# SIEMENS SOMATOM FORCE

## **Renovate for Cardiology Building 100, Second Floor CT Equipment Evaluation**

September 22, 2014 – VA 261-12-D-0077

VA Palo Alto Health Care System  
CT Equipment Evaluation

S-101

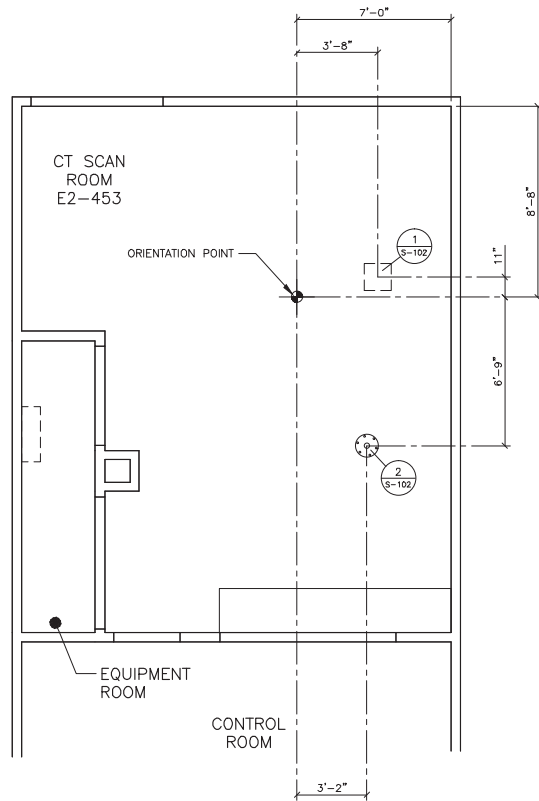
- Anchors at Floor represented on MEI architectural drawings:
  - There are multiple structural anchorage points at the CT Scanner and for other pieces of equipment.

- Detail 19 on sheet AS9-1A shows a beam at the anchorage location. It has been verified that a beam does not occur where Siemens has located anchorages.

- Detail 12 on sheet AS9-1A does not specify the required through-floor bolts for structural anchorage.
- Penetrations Through Floor represented on Siemens drawings:

- Under the CT Scanner, three closely spaced through-floor cores (3 and 4 inch diameter) are shown for running cabling. Note that closely spaced metal decking penetrations generally act as one large penetration.

- Fill existing unused core locations, provide new core locations where required by Siemens for new equipment and structurally reinforce floor.
- Install new wedge type anchor bolts at where required by Siemens for new equipment.
- Fill existing core in equipment closet. Provide new through-bolt at equipment cabinet due to proximity of previous core location.
- Lengthen overhead equipment supports where required.

### STRUCTURAL CEILING PLAN

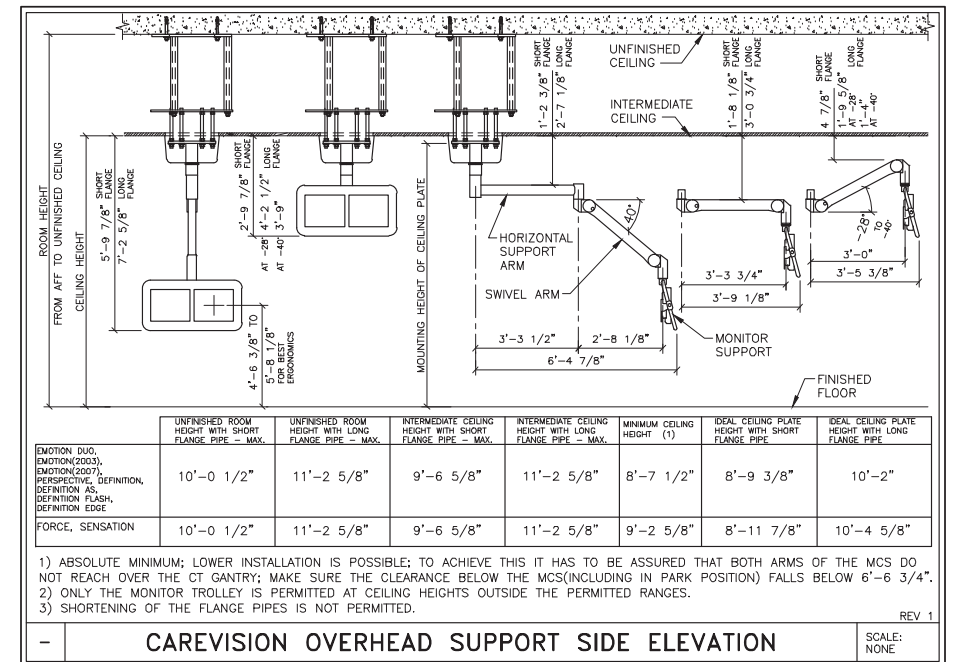
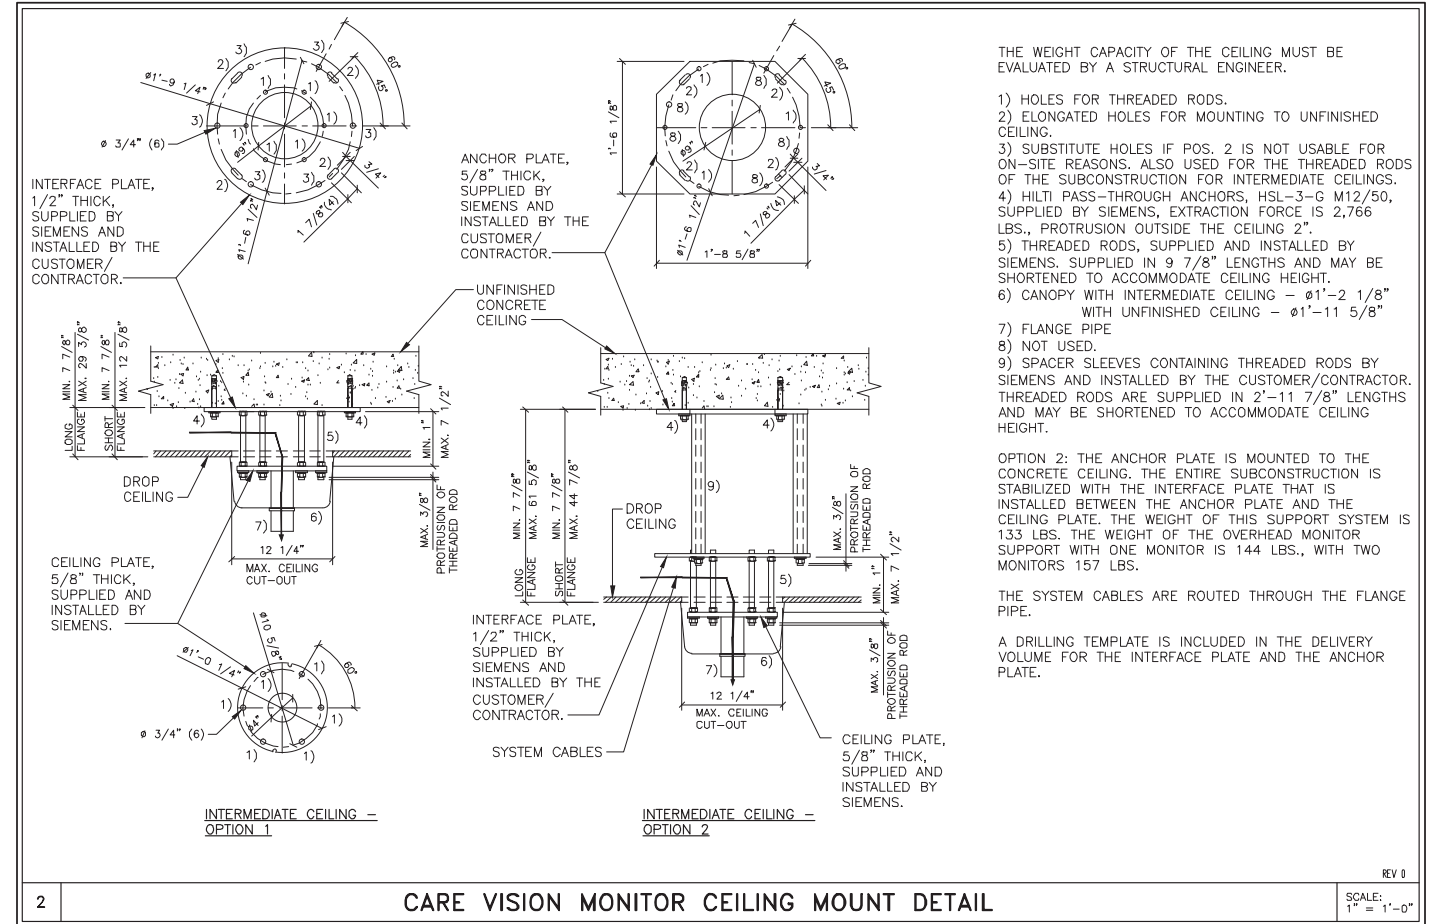
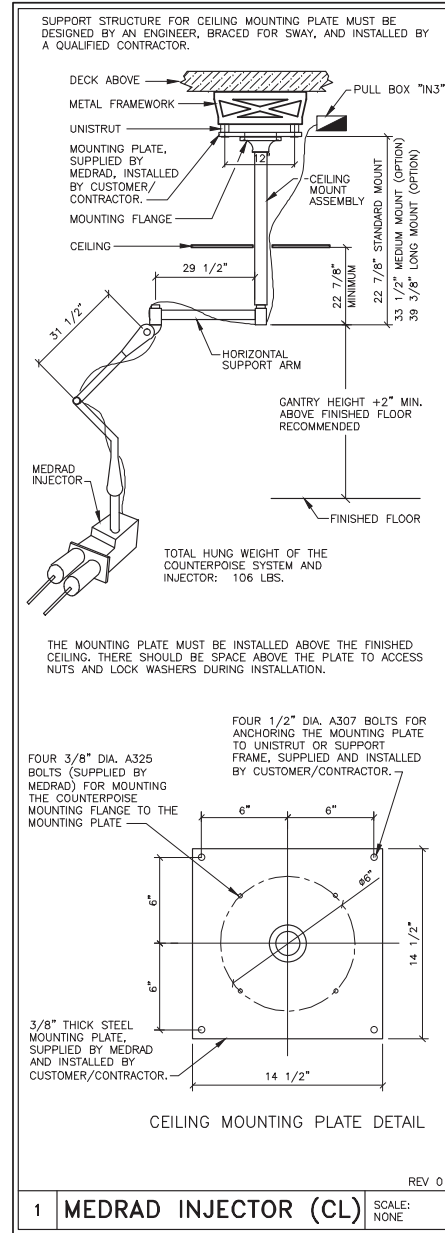
- Supports for Ceiling Mounted Equipment represented on MEI architectural drawings:
  - There are two ceiling mounted equipment items, one on each side of the gantry, with different base plate and bolt patterns.

- Detail 14 on sheet AS9-3 shows only one equipment.
  - Detail 14 on sheet AS9-3 shows a beam above the equipment for support. It has been verified that a beam does not exist where Siemens has located the two ceiling mounted equipment items.
